Re: **Comments Concerning Widespread Improper Reliance on Inadequate Analysis Concerning Hydrologic Connectivity of Groundwater Wells**
(Commercial Cannabis Permitting Program Under the CMMLUO and CCLUO)

Re: Review of Hydrogeologic Connection Investigation Memorandum Prepared for Platinum King Commercial Cannabis Project (Humboldt County, PLN-2018-15196)

**MEMORANDUM FROM RINEHART ENGINEERING
JULY 20, 2021**

Figure 1. Geologic map of the Petrolia-Honeydew area of Humboldt County, California. Note the convoluted bedding, steep dips, and widespread faulting.

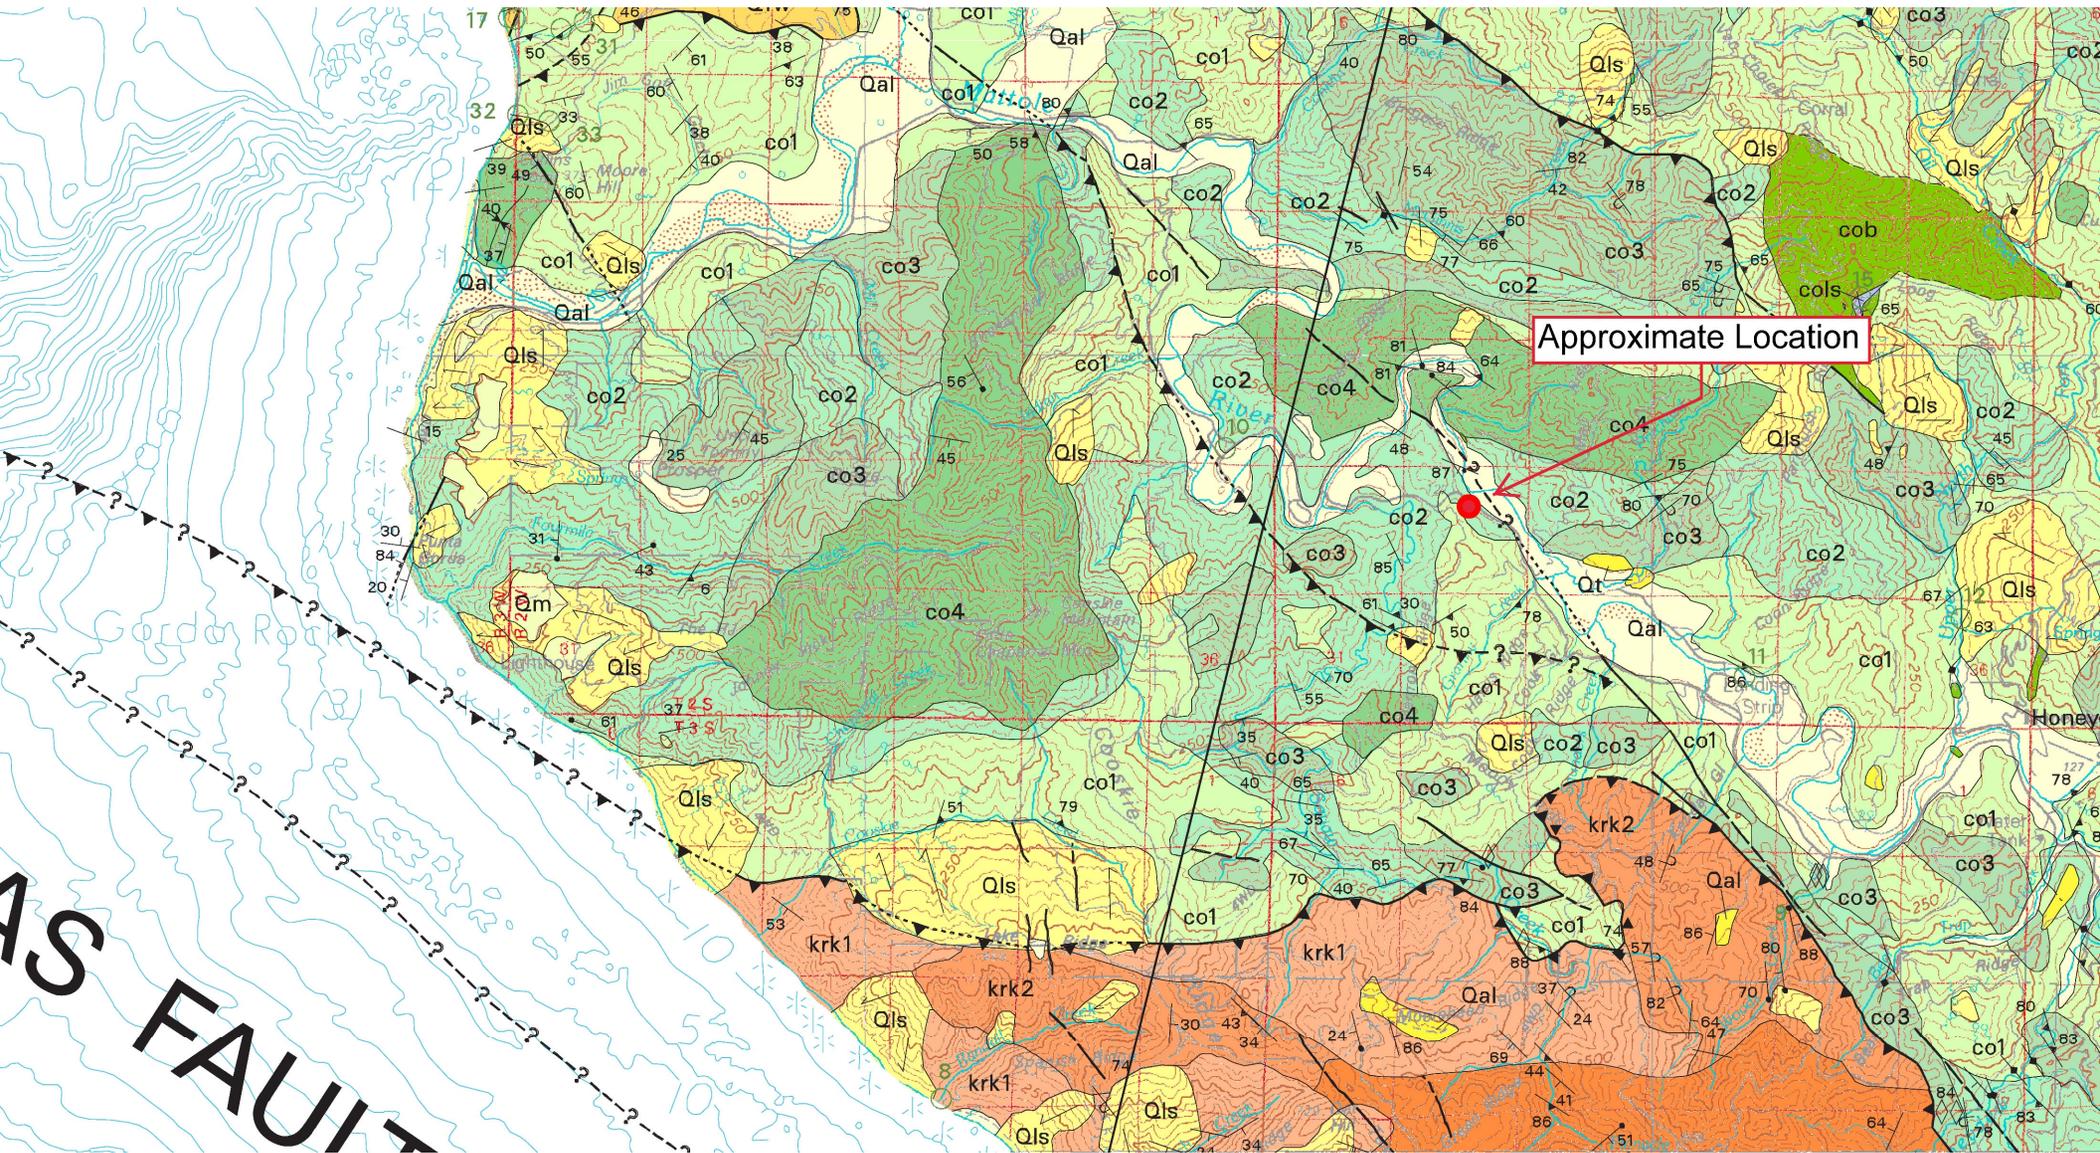
The wells are located near the Mendocino Triple Junction, probably the most seismically active portion of Humboldt County over the past several million years and counting. The local aquifers are heavily deformed, tightly folded, and physically torn apart. Groundwater conditions in the vicinity of the wells have been fundamentally affected. The geologic deformation – and how inconsistent with the memo’s assumption of an extensive confined aquifer -- is not recognized in the Reinhart memo.

The following four points describe why the highly deformed, faulted and fine-grained underlying geology of Franciscan sediments make it unlikely that a confined aquifer isolated from surface waters would occur in the Reynolds Road area. For more background, readers can seek out the U. S. Geological Survey’s regional geologic overview by McLaughlin and others (2000) and some of the narrower context of hydrologic response at this site to seismic activity is documented in part in McPherson and Dengler’s (1992) article in California Geology.

- a. Confinement of groundwater conditions require continuity of the affected aquifer, which the local geology does not provide:** The memo claims that confinement is the mechanism by which surface water bodies can be isolated from groundwater pumped at the two wells, which the memo implies may be interconnected. Any confining geologic unit must logically extend at least the distance (seemingly several hundred yards) between the two wells, and substantially beyond them. The geologic conditions at the site do not provide for such continuity. But there is nothing gentle, flat, or continuous about the local geologic structure. Figure 1 (Attachment C) shows geologic units which dip steeply and in almost every direction, chaotically folded. And the map shows that Coastal-Belt Franciscan deposits underlying the Reynolds Road area, even if not fragmented by the chaotic folding, are mélanges -- so fine-grained, squeezed, having peanut-

The likelihood of continuous aquifers or aquitards in the Reynolds Road area is vanishingly small.
